G3NO-2008-00016

SUBJECT: Responses to NRC Requests for Additional Information, Letter No. 15  
(GG3 COLA)

**RESPONSE TO NRC RAI LETTER NO. 15**

# Nuclear Project Structure – RB3N & GG3N

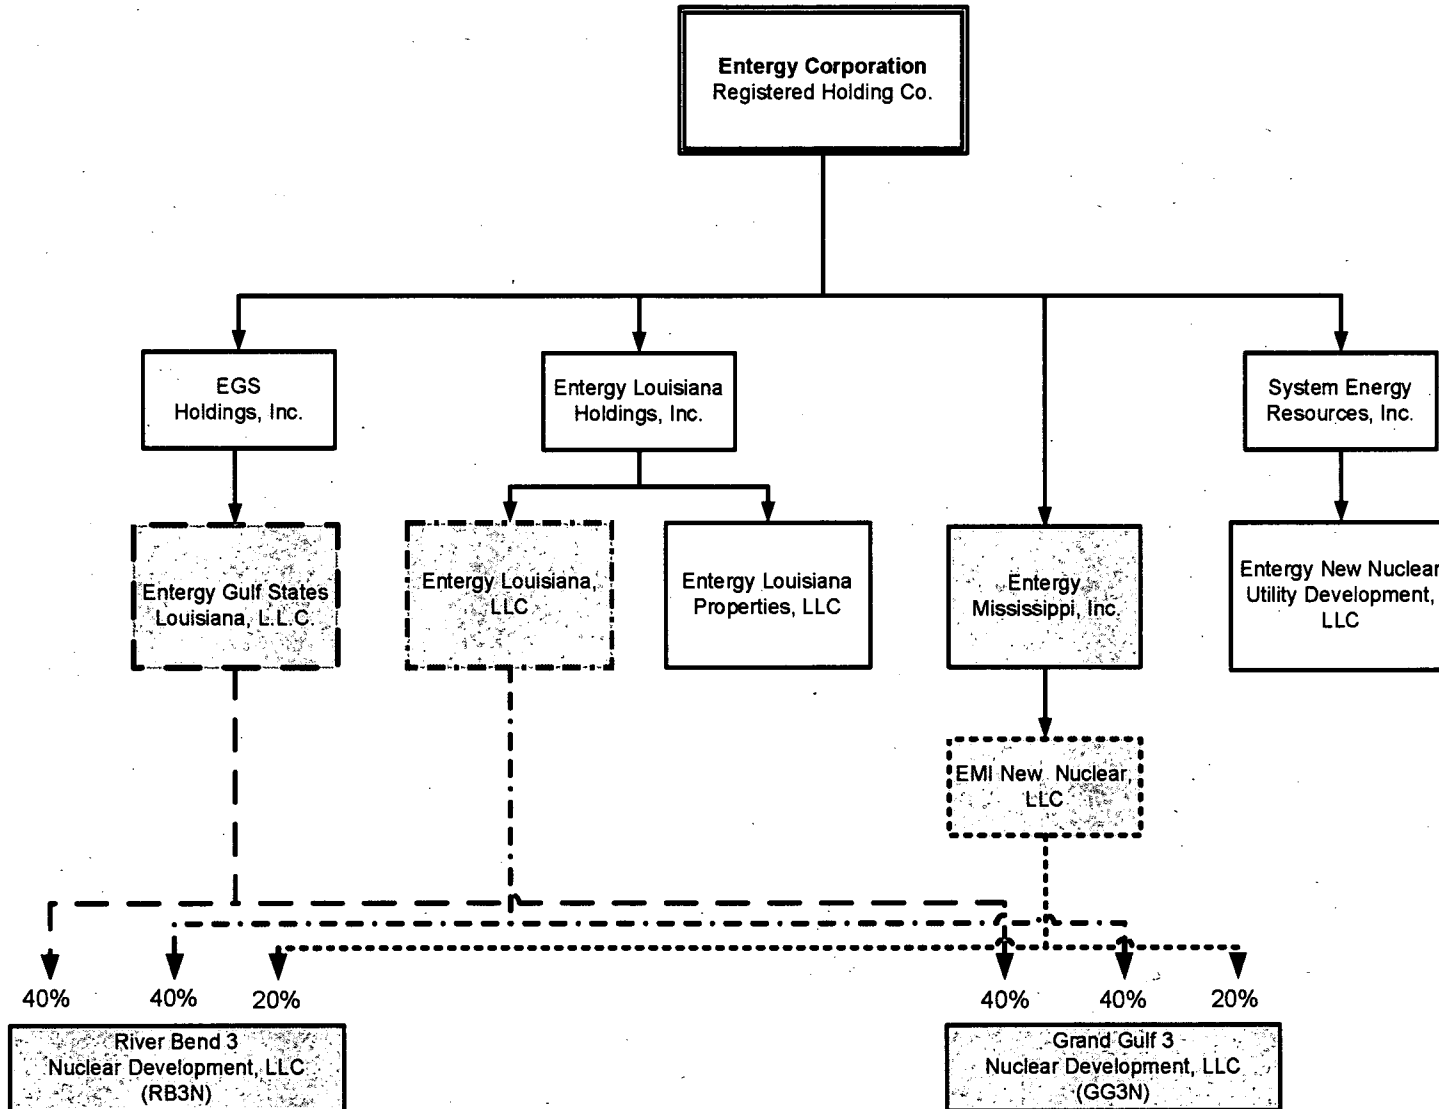
- a) In Section 1.1 – Applicants – Corporate Information, the application states that Entergy Mississippi, Inc. (EMI); Entergy Louisiana, LLC (ELL); and Entergy Gulf States Louisiana, L.L.C. (EGSL) will own GGNS Unit 3. However, the application also states that “The ownership shares among these three companies have not yet been determined.” The staff requests that the applicants state when the percentage of ownership of GGNS Unit 3 between EMI, ELL, and EGSL will be finalized.
- b) In Section 1.1 – Applicants – Corporate Information, please provide an abbreviated chart showing the relationship of EMI, ELL, and EGSL to the parent company, Entergy Corporation.

- b) Currently, the project to be licensed under the GGNS Unit 3 COL application is expected to be owned entirely by GG3N, which in turn will be owned entirely (directly or indirectly) by Entergy's regulated utility operating companies EMI, ELL, and EGSL.

The diagram below shows the relationship between Entergy Corporation and the regulated utility subsidiaries participating in the project.
